Access Compliance Report Public Rights-of-Way (Curb Ramps)

Intersection ID: 50588Main Street:BENDING_BRANCH_RDCross Street:DOWNY_BIRCH_RDLocation:SWADA ID: BBA7B0DE23B1Ramp Type:PerpInitial Pass/Fail:FailOverall Compliance:NoSeverity Score:22.5

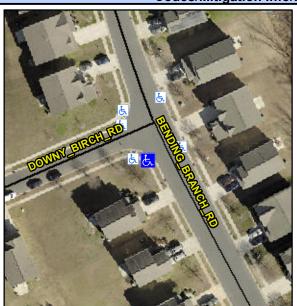
Not Found, R304.5.1, R304.2.2, R304.5.3

Compliance Description Data Compliance Description Data No N/A Ramp Length (in) 47.5 Ramp Slope (%) 11.7 No Ramp XSlope (%) No Ramp Width (in) 47.0 3.3 N/A N/A Flare Type LT N/A Flare Type RT N/A N/A N/A N/A Flare Slope RT (%) N/A Flare Slope LT (%) N/A Flare Traversable LT? N/A N/A Flare Traversable RT? N/A N/A N/A N/A **DWS Provided?** N/A Landing Length (in) N/A Landing Width (in) N/A N/A **DWS Contrast?** N/A N/A N/A N/A Landing Slope (%) DWS Length (in) N/A N/A Landing X Slope (%) N/A N/A DWS Full Width? N/A N/A Landing Curb? (Y/N) N/A N/A DWS Offset (in) N/A N/A N/A Shared Landing? N/A **Gutter Ponding?** N/A N/A Gutter Slope (%) N/A N/A Gutter Lip Ht (in) N/A N/A Gutter X Slope (%) N/A N/A Painted X Walk1? No N/A Painted X Walk2? N/A X Walk 1 Direction To E X Walk 2 Direction N/A N/A N/A X Walk 1 Width (in) X Walk 2 Width (in) N/A X Walk 1 Slope (%) 2.8 X Walk 2 Slope (%) N/A X Walk 1 X Slope (%) 2.5 X Walk 2 X Slope (%) N/A N/A N/A N/A Ramp inside XWalk2? Ramp inside XWalk1? N/A Road Slope (%) N/A N/A Clear Space? N/A N/A Road X Slope (%) N/A Clear Space to XWalk (in) N/A N/A N/A Any Obstructions? N/A Storm Grate/Utility Hazard? N/A **Obstruction Type** Storm Grate/Utility Type N/A N/A

Remove & Replace Entire Ramp.
